**RE: City of Burbank Comments on Draft Environmental Impact Report / Draft Environmental Impact Statement for the California High Speed Rail System – Burbank to Los Angeles Section**

CITY OF BURBANK  
CALIFORNIA HIGH SPEED RAIL PROJECT  
BURBANK TO LOS ANGELES DEIR/DEIS  
COMMENT LETTER

**SUBJECT:** California High Speed Rail Project Draft Environmental Impact Report Comment Letter

CONTRACT NO.  
HSR14-39  
DRAWING NO.  
TT-D1202  
SCALE  
AS SHOWN  
SHEET NO.

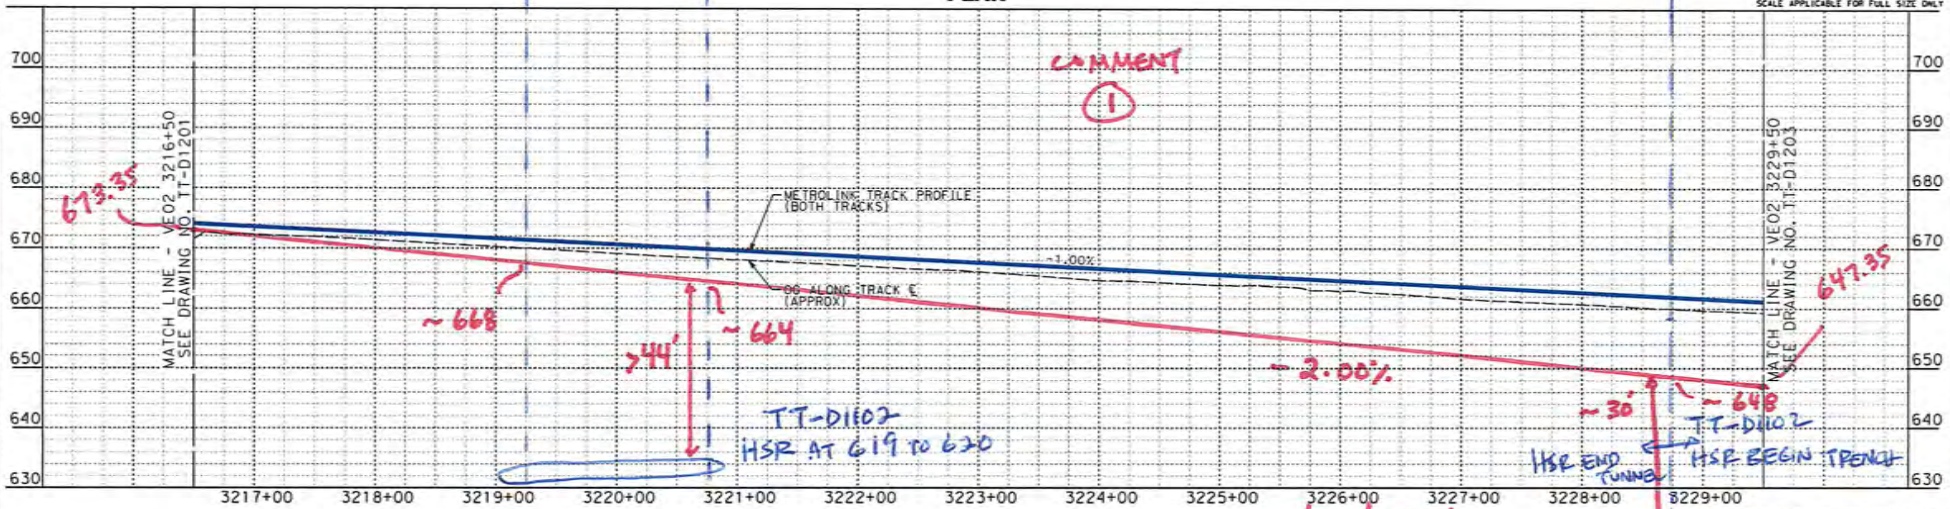
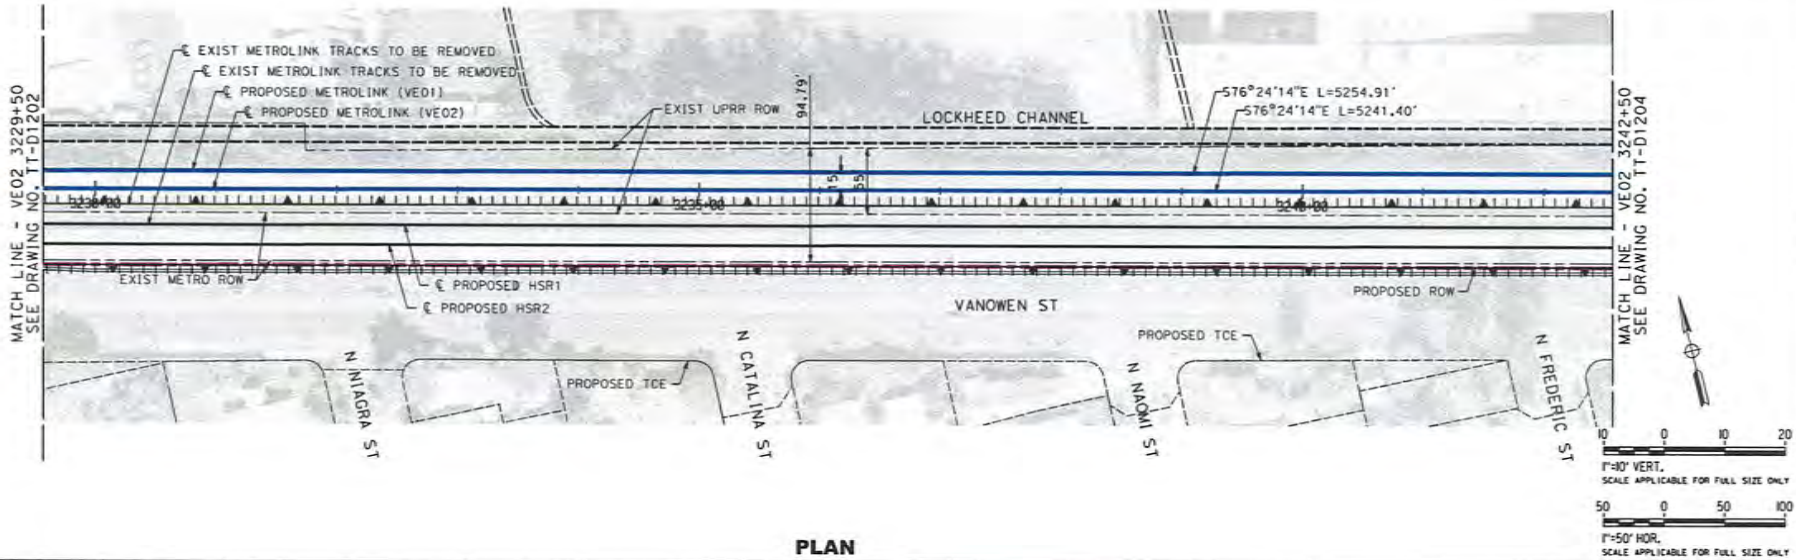
- The City requests to change the crossing for Metrolink and UPRR tracks to also be grade-separated and below Buena Vista Street. **(Page 2-52)**
- Grade separation may be accomplished using a -2.00% slope from STA 3215+72.96 to STA 3245+00. **(Sheet TT-D1201, 1202, 1203)**

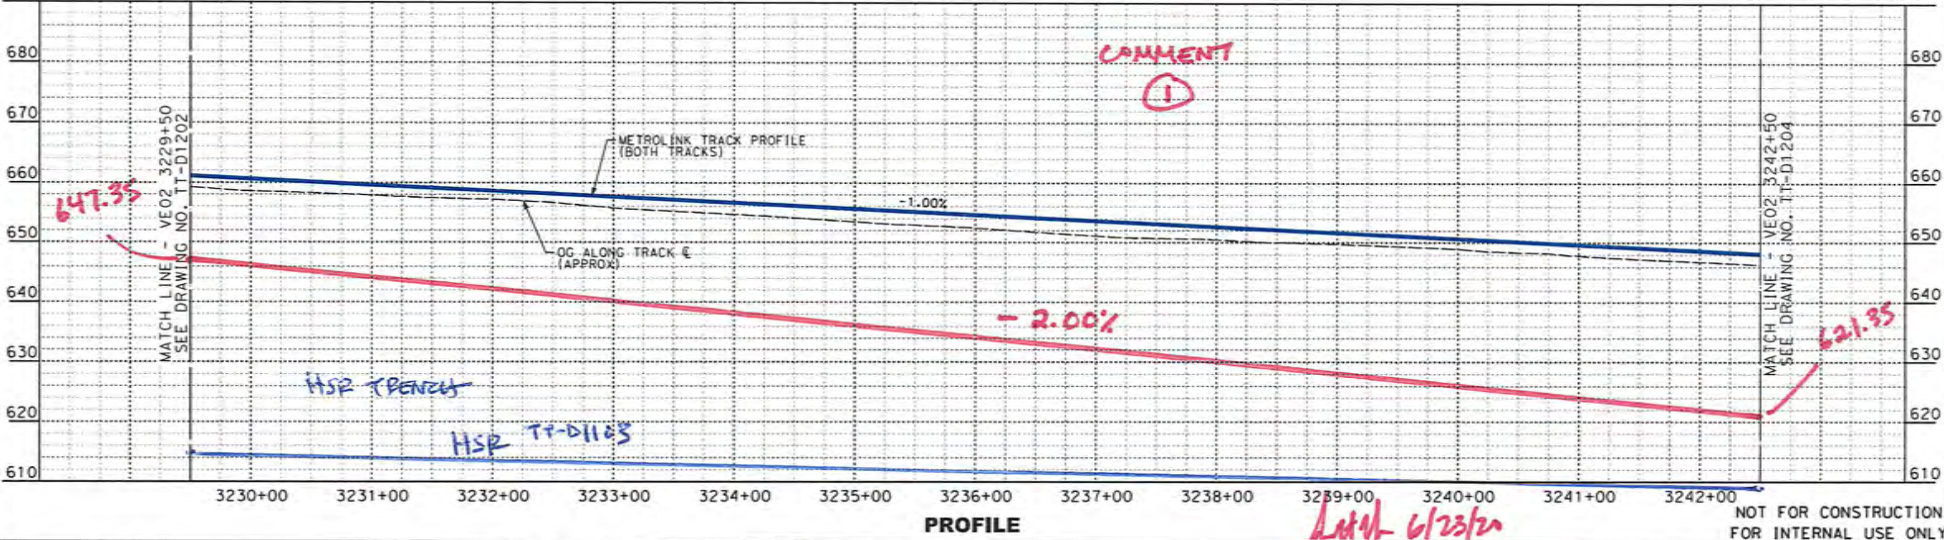
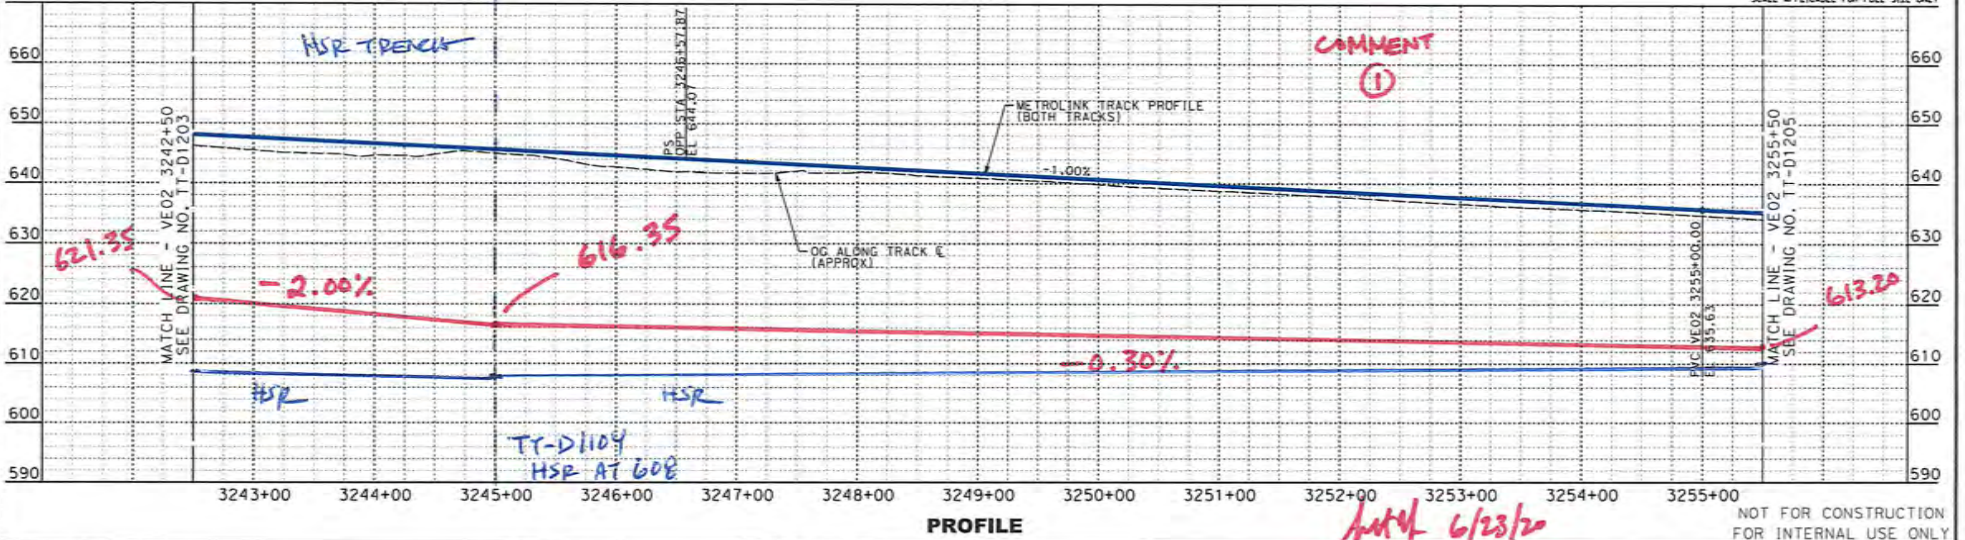
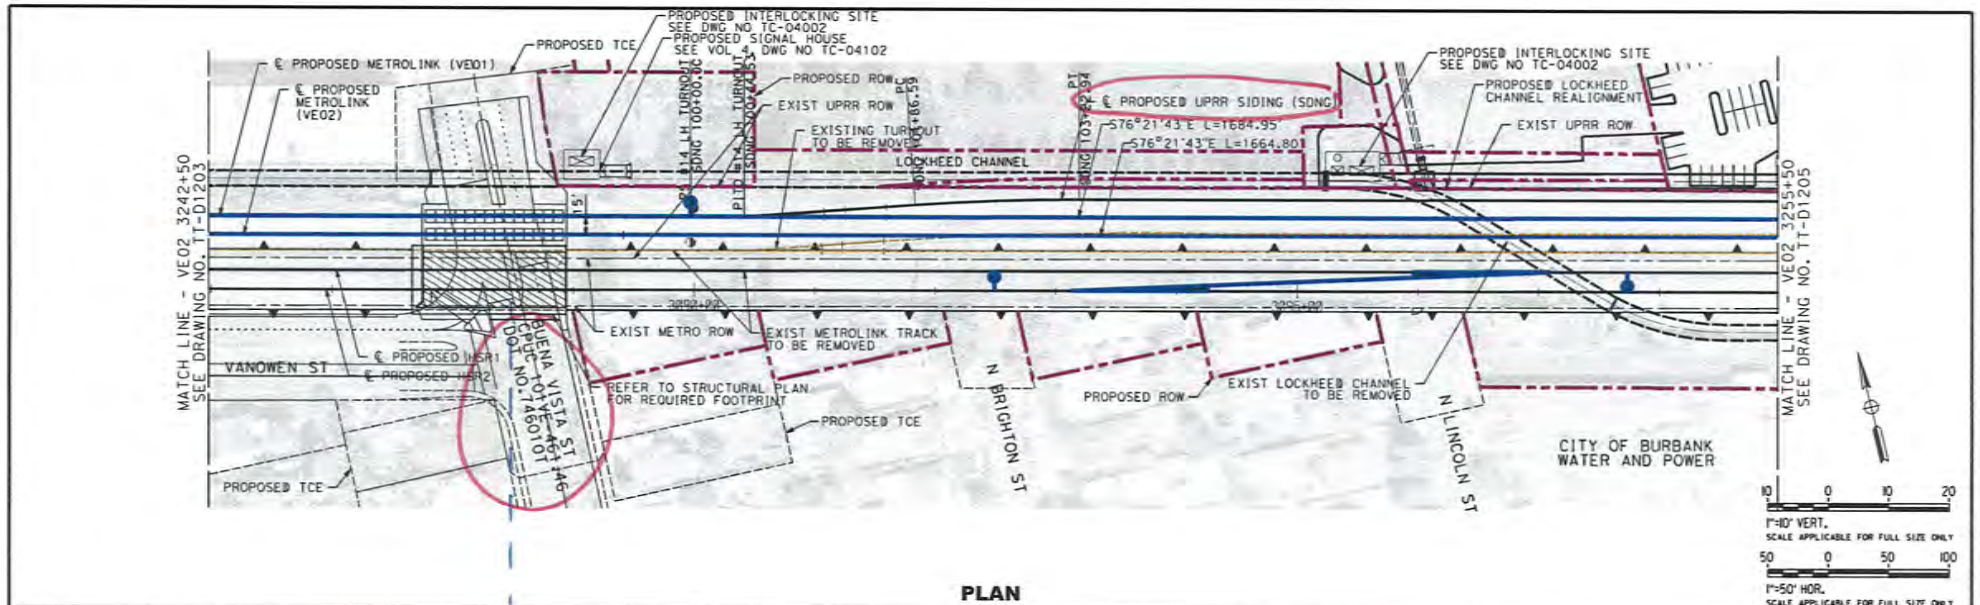
- Grade separation may result in a -0.30% slope from STA 3245+00 to STA 3291+65.95. **(Sheet TT-D1203, 1204, 1205, 1206, 1207)**
- Grade separation would require construction using a joint trench for Metrolink, UPRR, and HSR tracks and therefore the shoofly must be extended to allow rail operations.

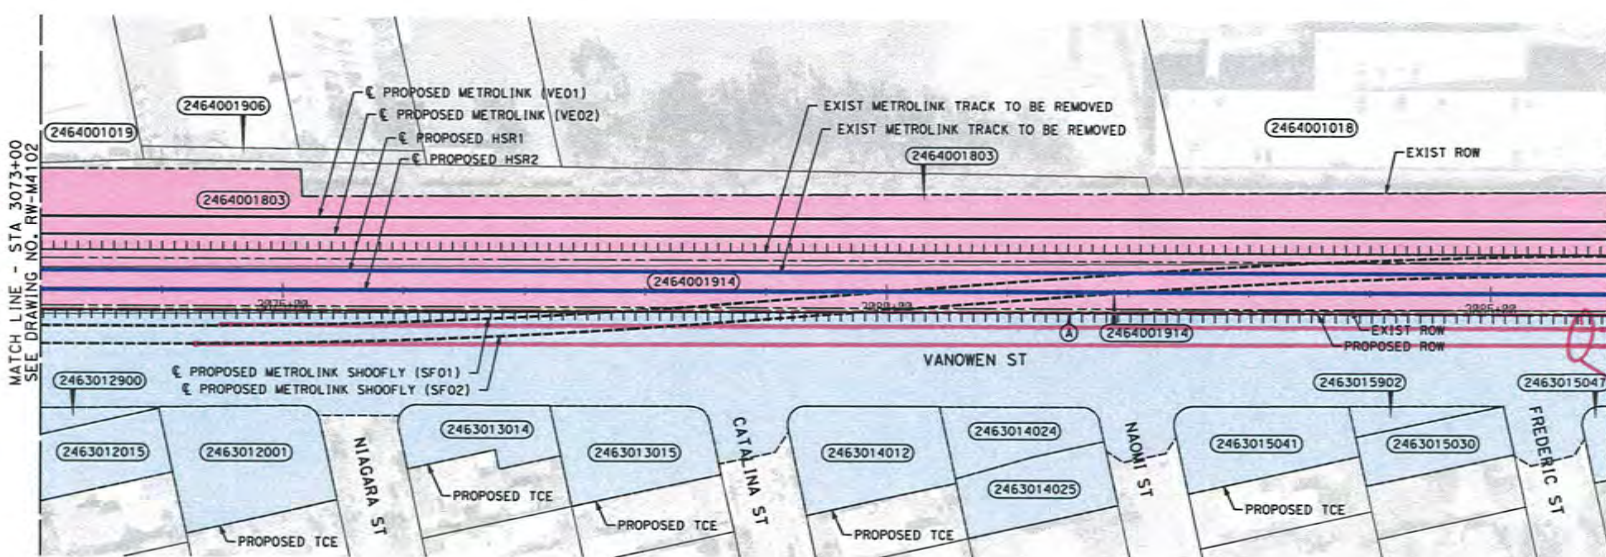
**COMMENT**  
 ②  
 EXTEND SHOOFLY TO GRADE SEPARATE METROLINK/UPRR TRACKS AT BUENA VISTA

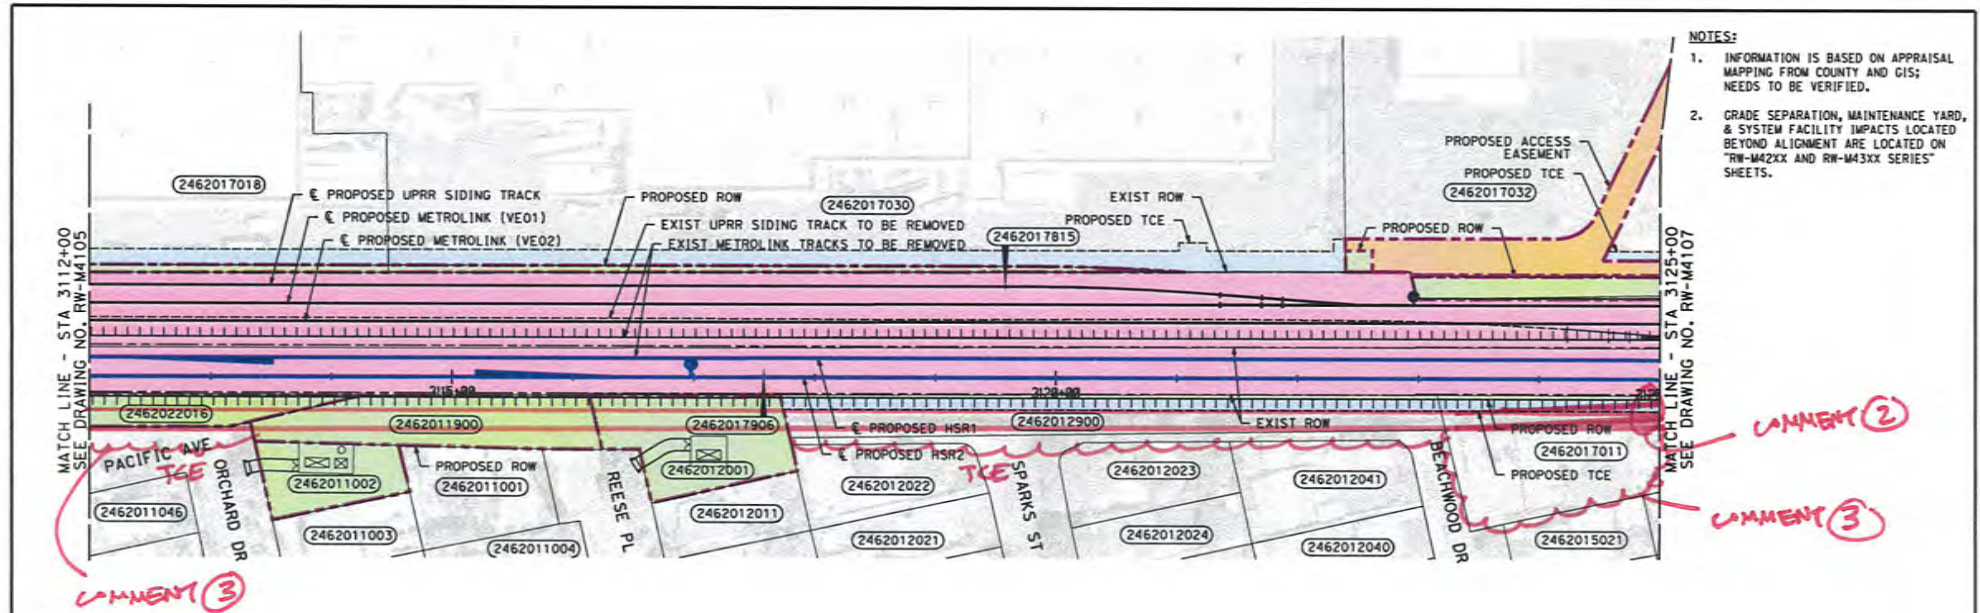
- The shoofly extension will require additional right of way impacts, including parcels 2462002036, 2462002009, 2462002006 **(Sheet RW-M4104)**, parcels 2462002002, 2462002003, 2462002004, 2462002005, 2462002006, and Pacific Avenue **(Sheet RW-M4105)**, parcels 2462012900, 2462017011, and Pacific Avenue **(Sheet RW-M4106, 4107)**.

COMMENT (3)

COMMENT (2)

COMMENT (3)

ELECTRICAL SERVICES DIVISION					
					G.O. 95 CLEARANCES					
					DRAWING No. <b>S-708</b>					
No.	REVISIONS				BY	CHECK	APP'V'D	DATE		
DRAWN	DSL	SCALE	NTS	CHECK	APP'V'D	DATE		8/4/03

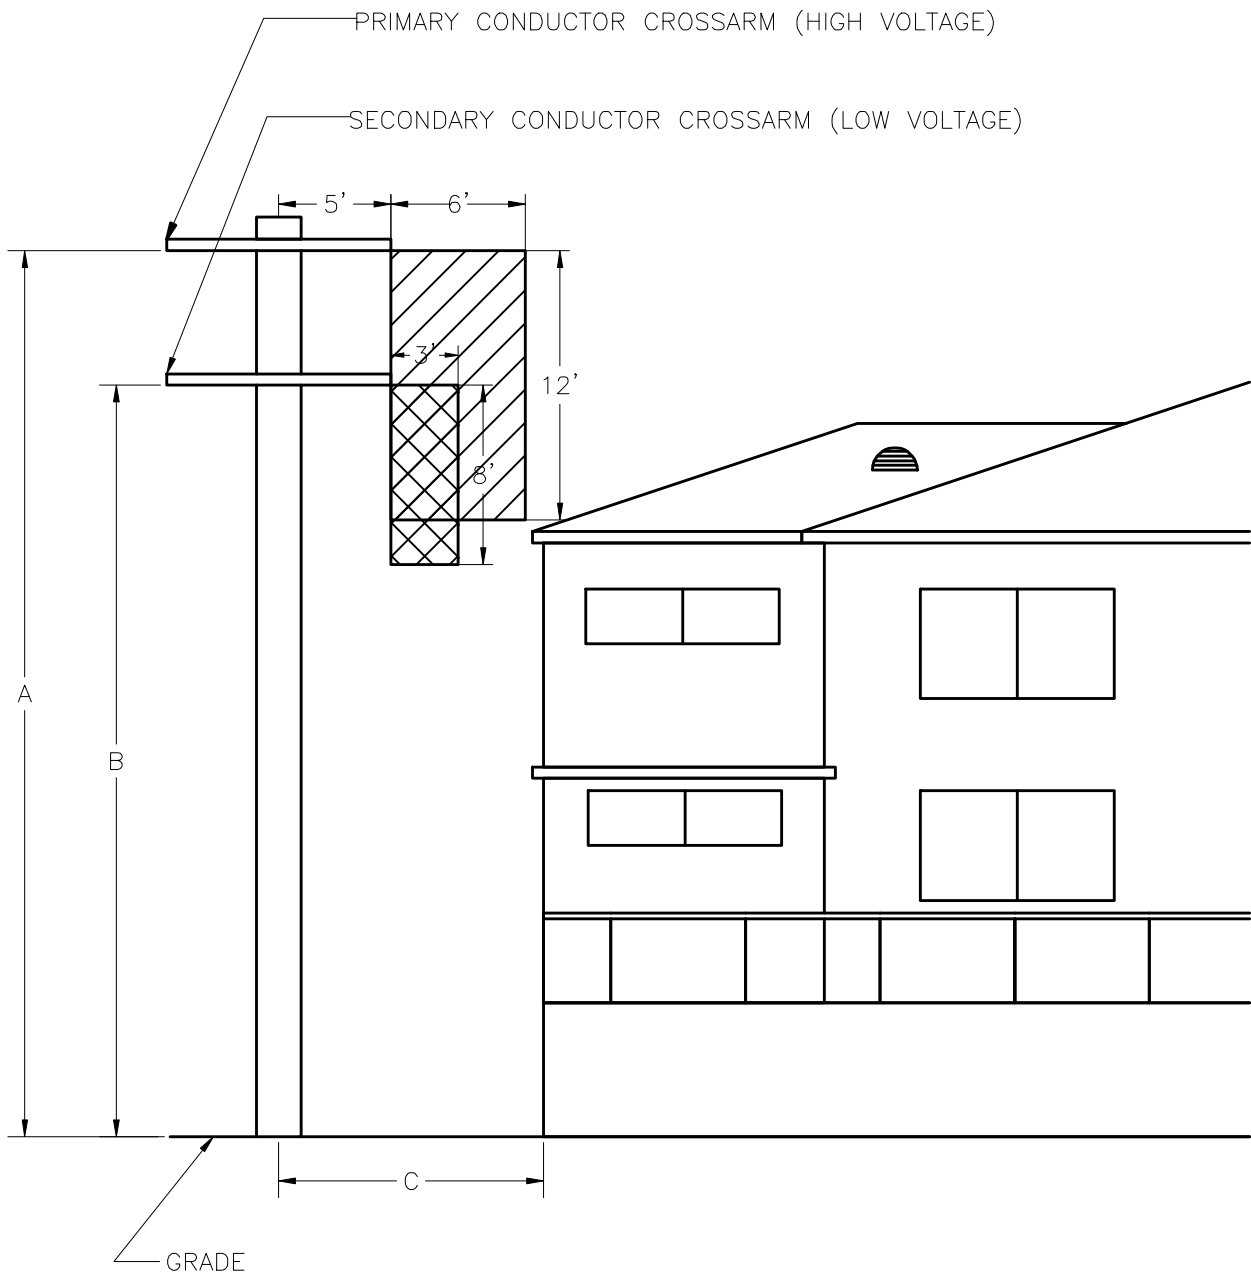
28. Plans must be revised to avoid encroachment into the envelope as commented above. Building elevations will show the existing power poles, their height from natural grade, conductor attachment heights and locations (all surveyed), and the described above envelopes clear from any portion of the building per BWP drawing S-708 (attached).
